**STAFF REPORT
PLANNING MANAGER DECISION**

DATE: July 14, 2020
 FILE NO.: DR-20-05
 REQUEST: Approval of a Class I Historic Design Review at 1709 5th Avenue
 PLANNER: Darren Wyss, Acting Planning Manager

**Houston Residence
Remodel**

A2.1

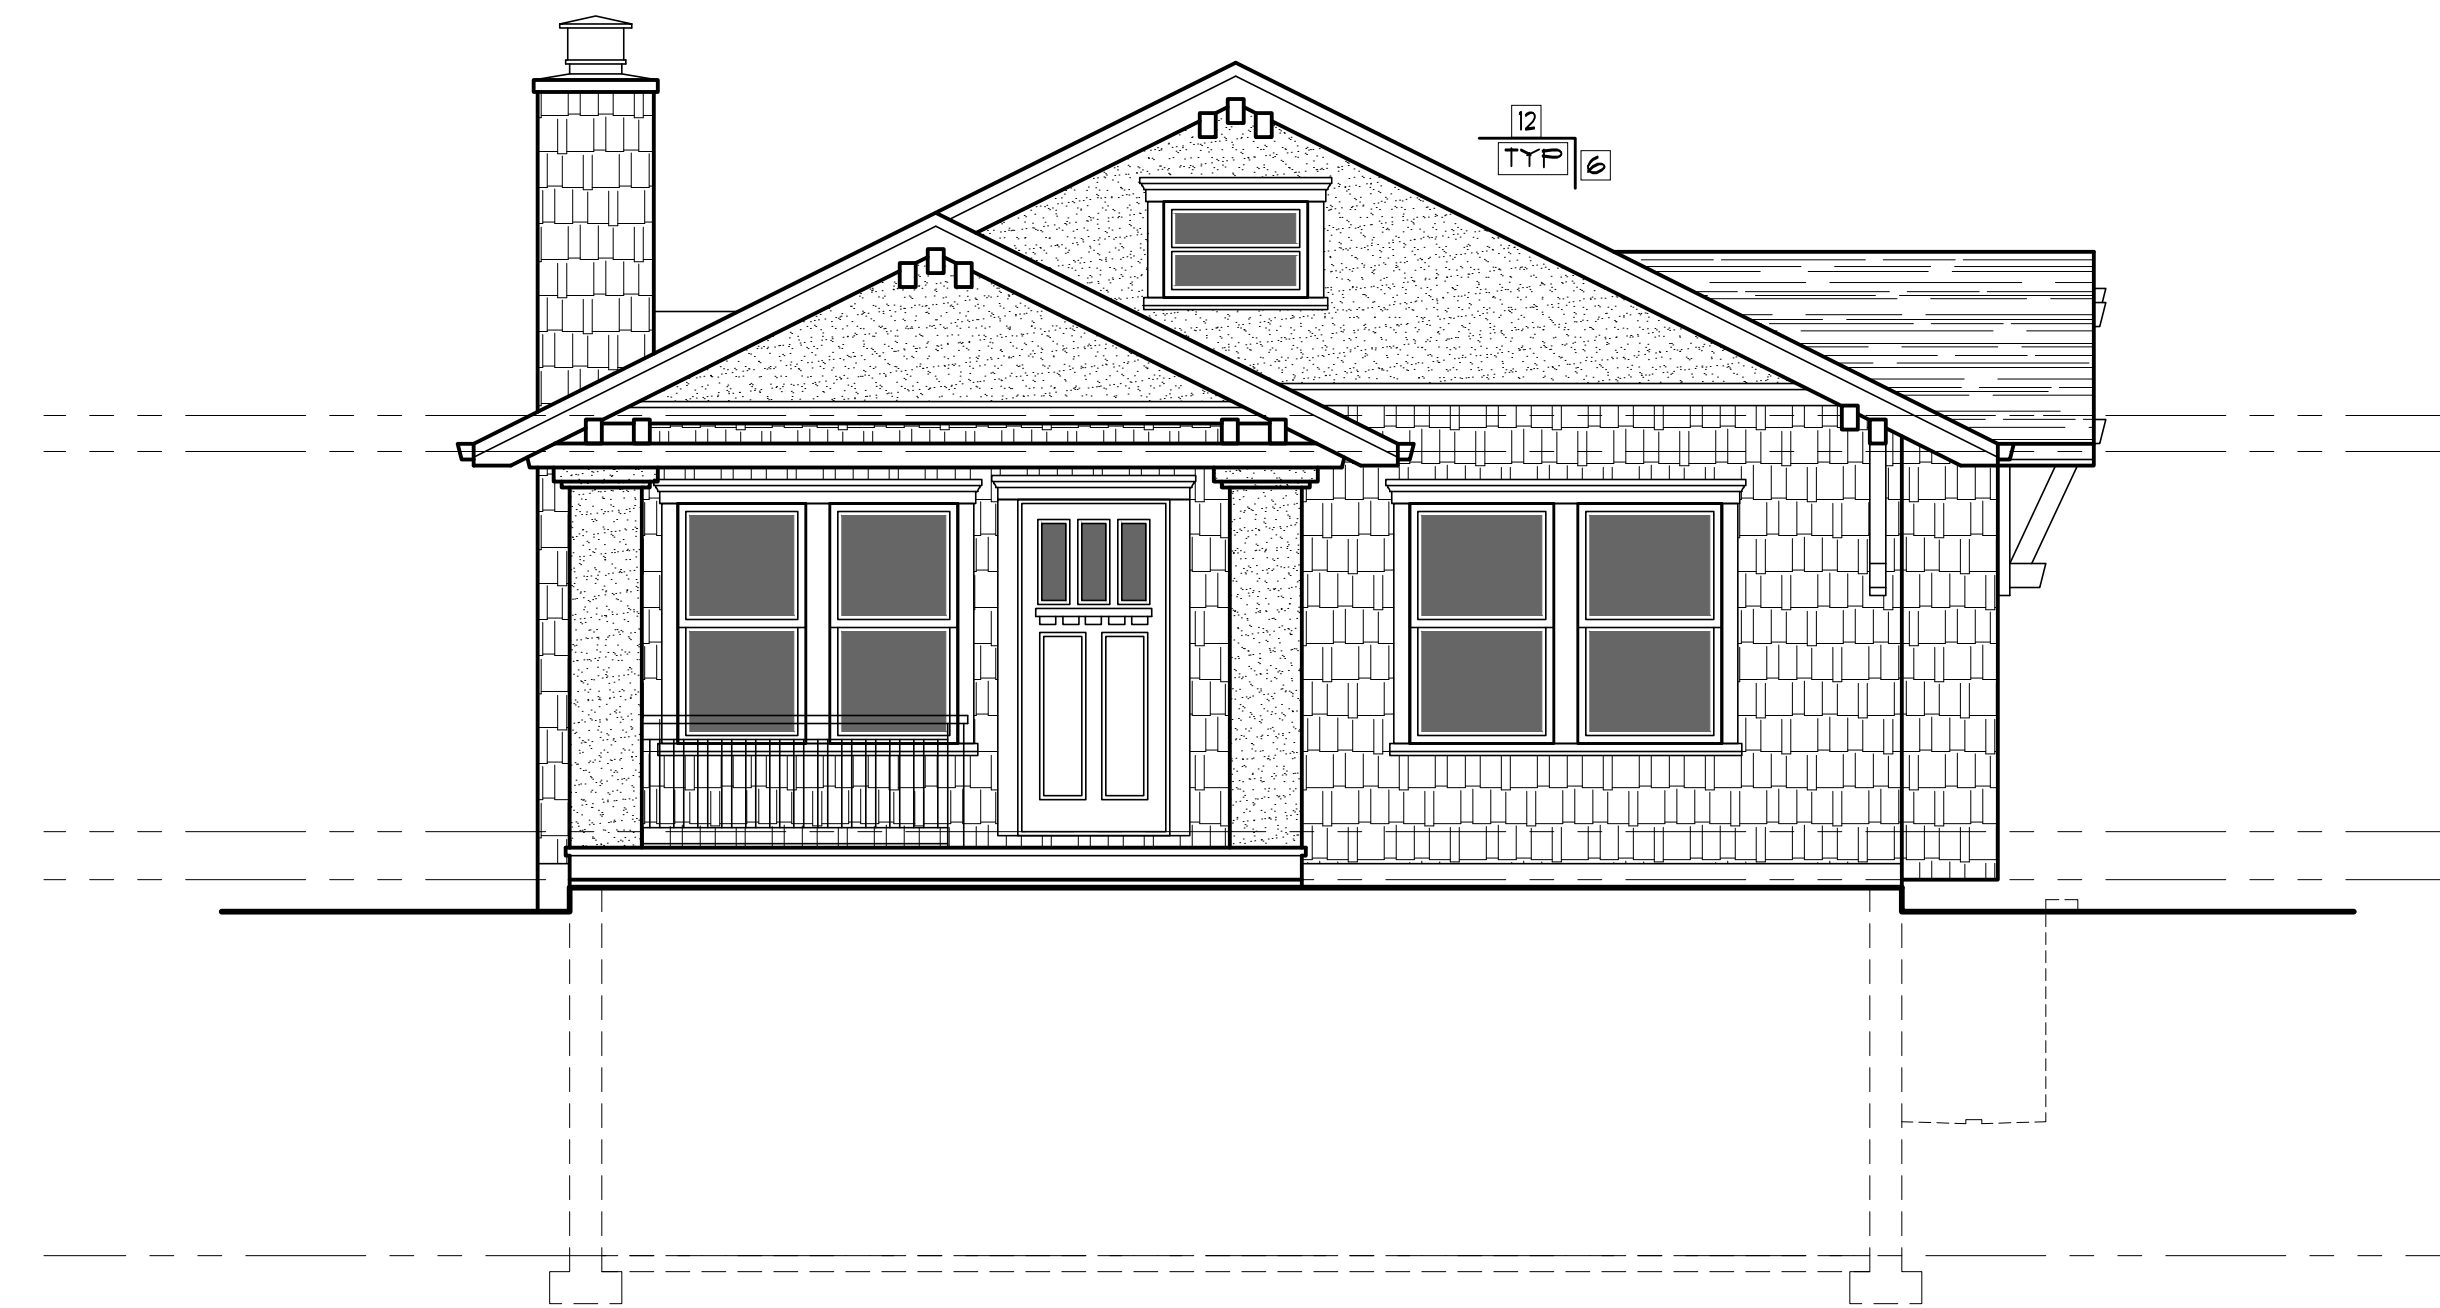
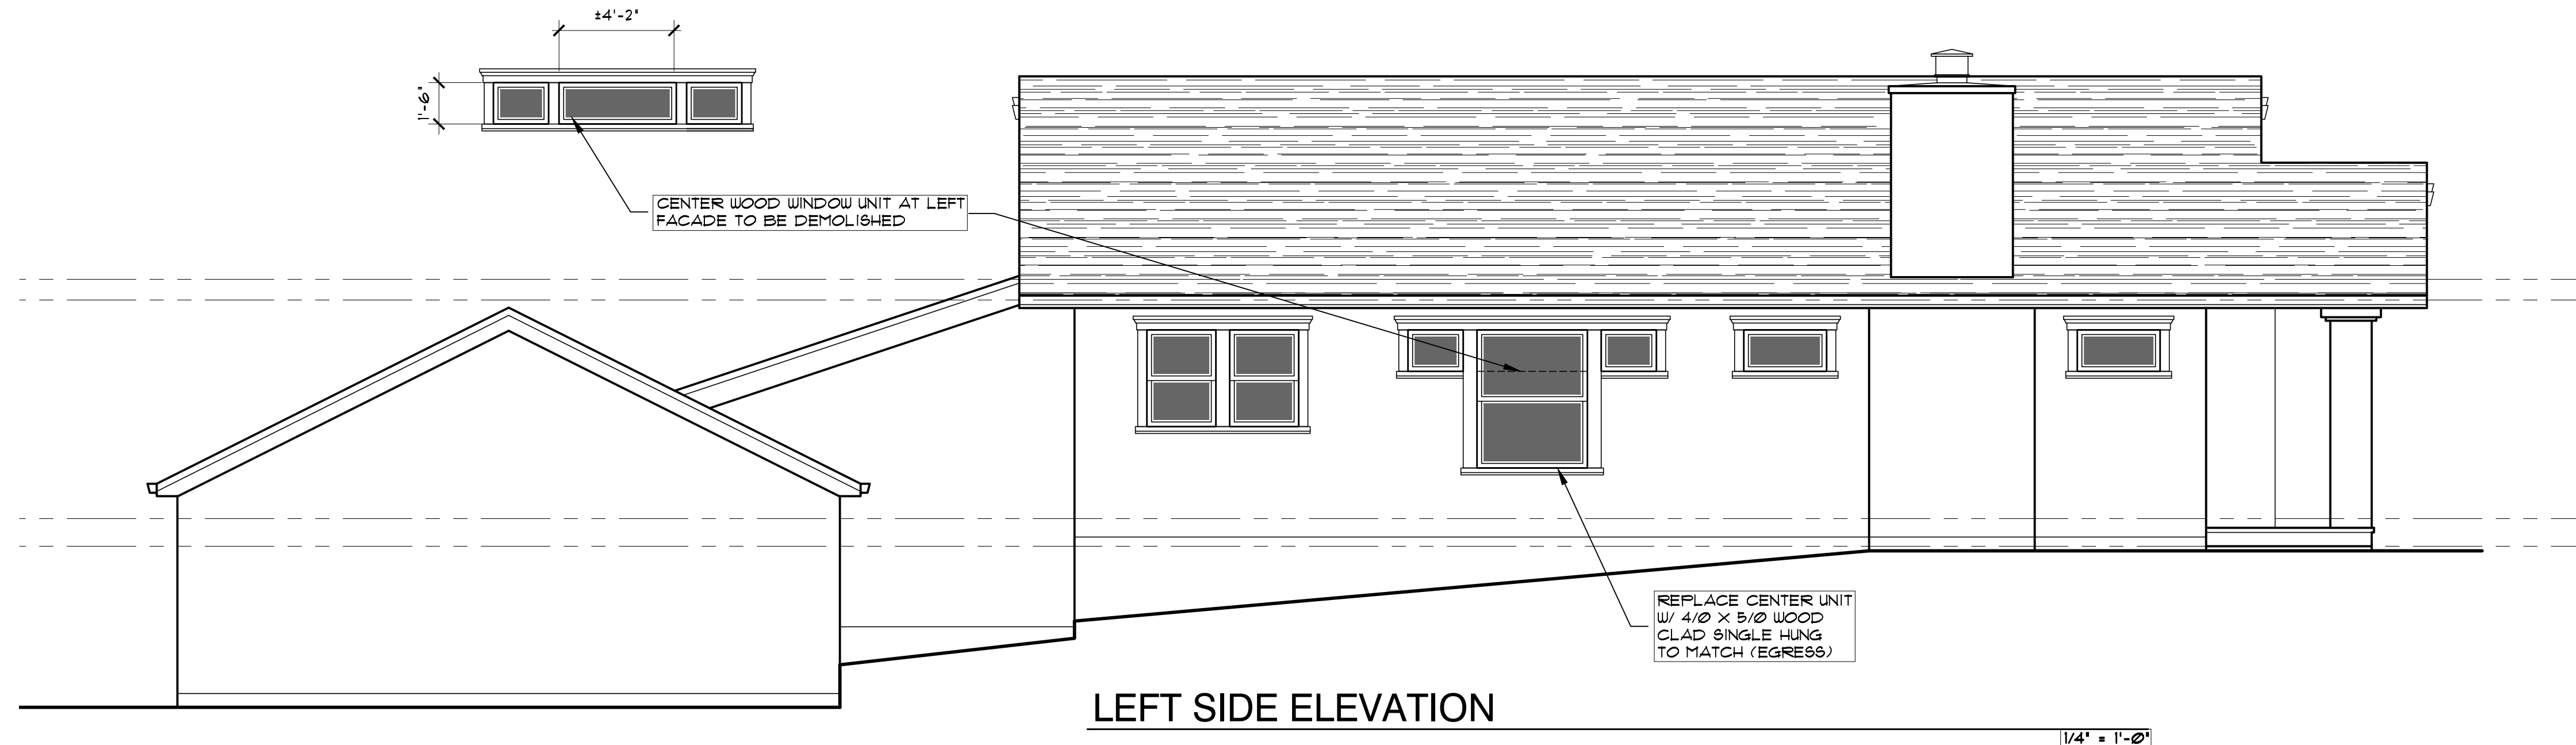
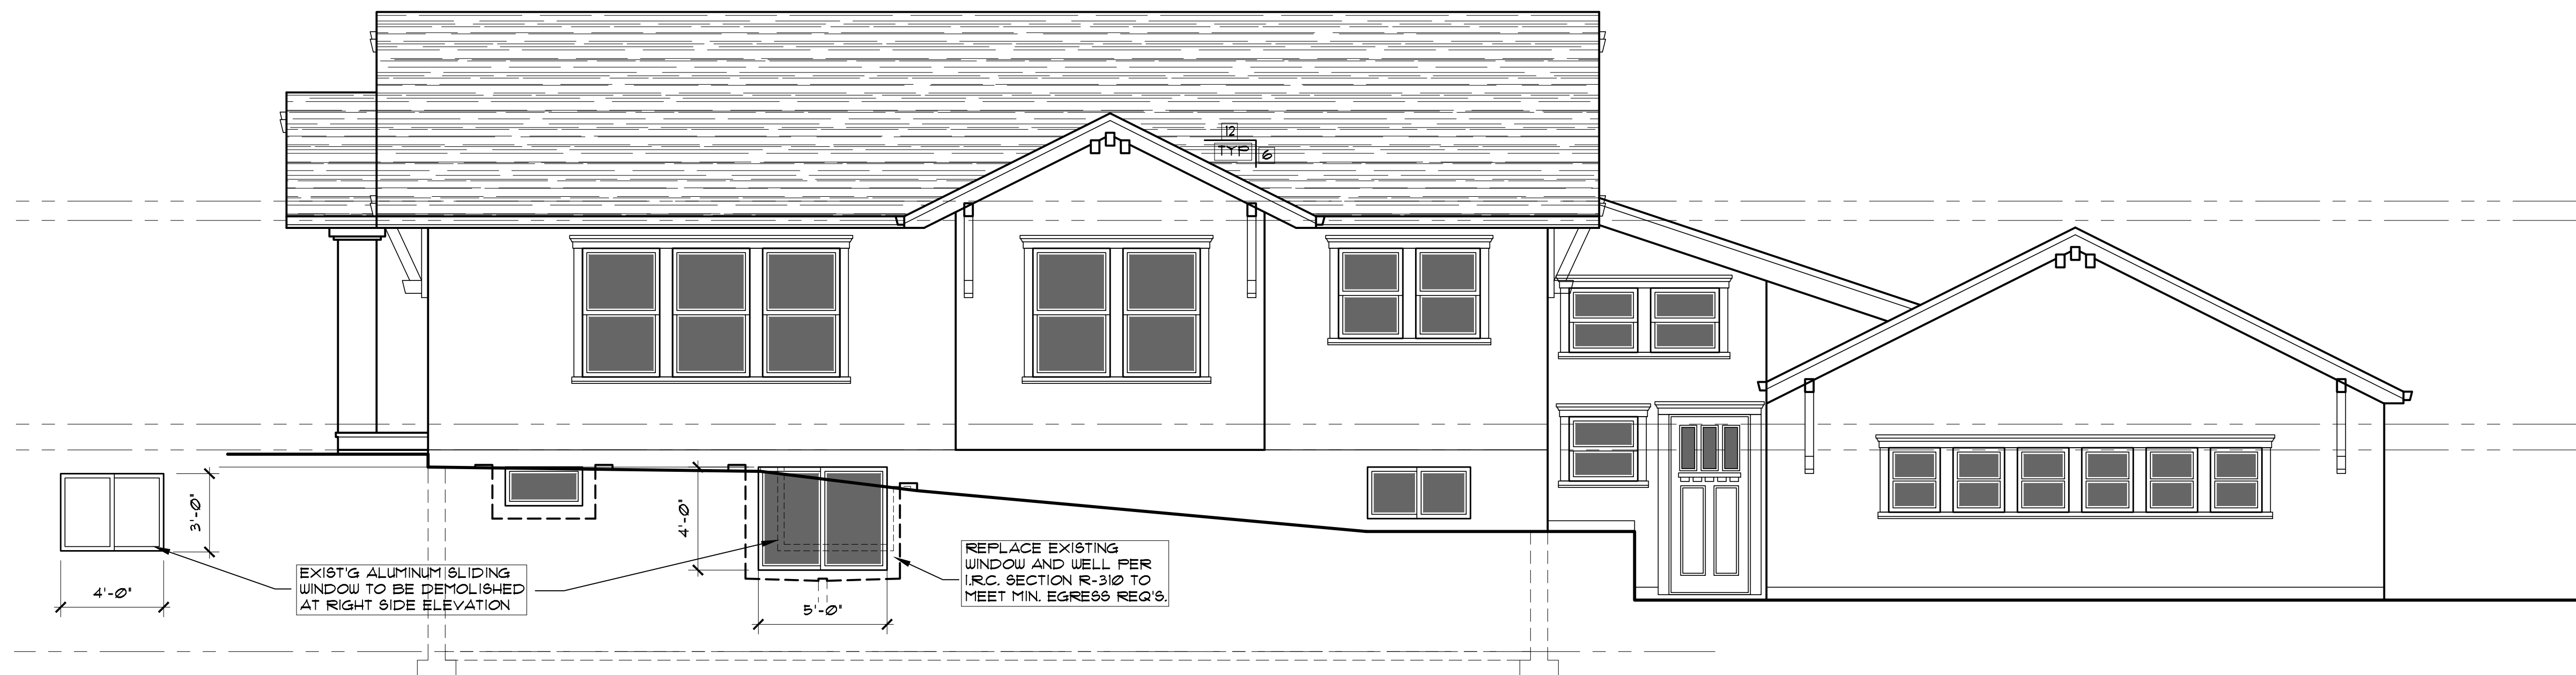
Staff Finding 4: The applicant proposes to replace the existing 18-inch by 50-inch wood window on the east elevation with a new 48-inch by 50-inch single-hung wood clad window to meet egress requirements. The profile and proportion of the sash, light patterns, and glass will remain the same (Page 14, Exhibit PD-1). The sill and trim will match. The criteria are met.

Staff Finding 6: The applicant proposes to replace the existing 18-inch by 50-inch wood window on the east elevation with a new 48-inch by 50-inch single-hung wood clad window to meet egress requirements. The profile and proportion of the sash, light patterns, and glass will remain the same (Page 14, Exhibit PD-1). The sill and trim will match. The criteria are met.
